World Forum for Harmonization of Vehicle Regulations

Working Party on Lighting and Light Signalling (GRE)

Proposal for Supplement 20 to the 00 series of amendments to Regulation No. 23 (reversing lights)

Submitted by the expert from Germany*

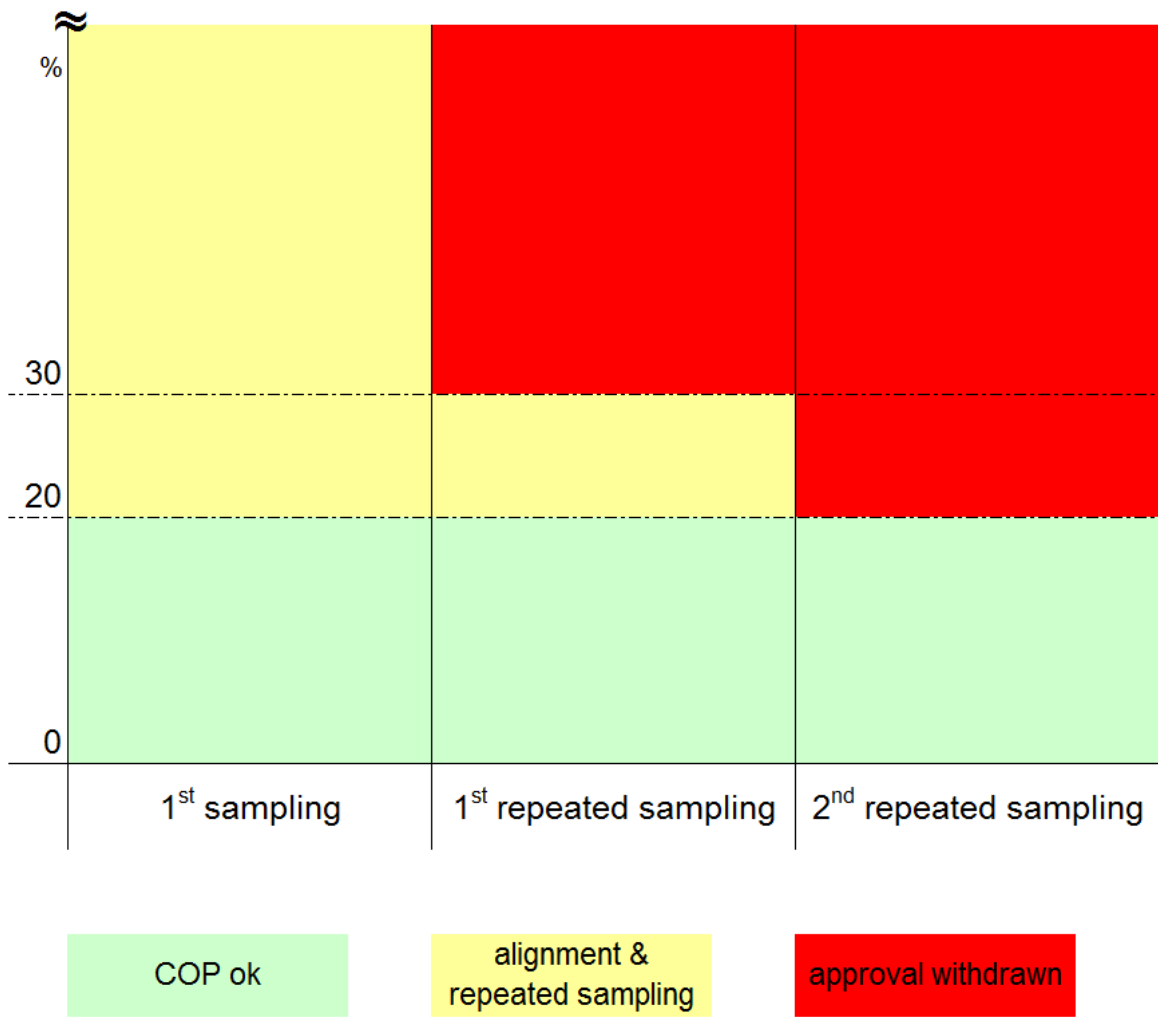
6. CoP is now described in a clear structured stepwise process (with limited steps), which gives the manufacturer the chance in the first step - in the case of deviations of more than 20 per cent - to align his production process. Also, the CoP process can be completed earlier when the first two samples are in the full specifications.

7. The proposal details the "third step" which defines the condition where the approval shall be withdrawn, when after the second repetition of this process the manufacturer was not in the position to "align" his production process in the correct way.

8. The attached drawing shall demonstrate this stepwise process.
